SUBJECT: RIVER BEND STATION - NRC EXAMINATION REPORT 05000458/2019301

ER 05000458/2019301; Initial Operator Licensing Examination Report

## NRC Resolution to the River Bend Station Post-Examination Comments

Photos: RAW DATA deselected, Full Core Display indicates 00 for each rod.

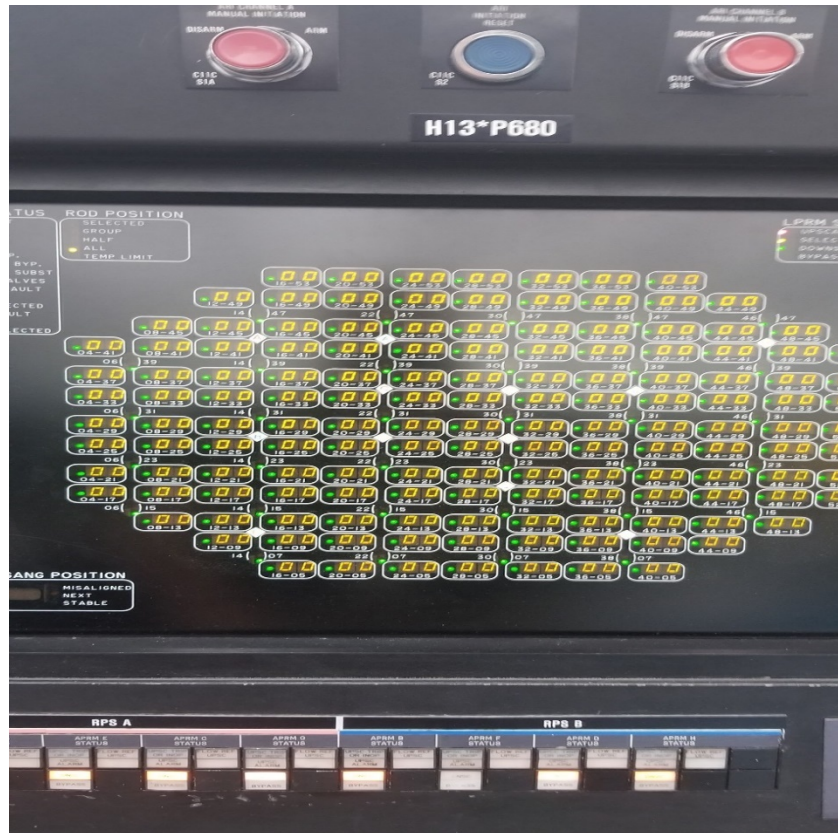
**COMMENT:** During simulator training, the students were taught to use both methods (RAW DATA selected and deselected). When RAW DATA is selected the position will indicate - -. When RAW DATA is deselected, and ALL RODS is depressed 00 will be indicated on the full core display. See photos for illustration. The students were trained to use both methods to verify all control rods are fully inserted. Based on the training provided and simulator performance answers A and D should be correct answers.

**NRC RESOLUTION:** The NRC agreed with the licensee's recommendation to accept both answers A and D as correct answers for Question 43. Whether the applicants were trained to use both methods to verify all control rods inserted is irrelevant. The question asked which method **COULD** be used, and either method could be used, even if one is preferred over the other. The NRC changed the answer key for the written exam to accept both answers A and D as correct answers to Question 43.
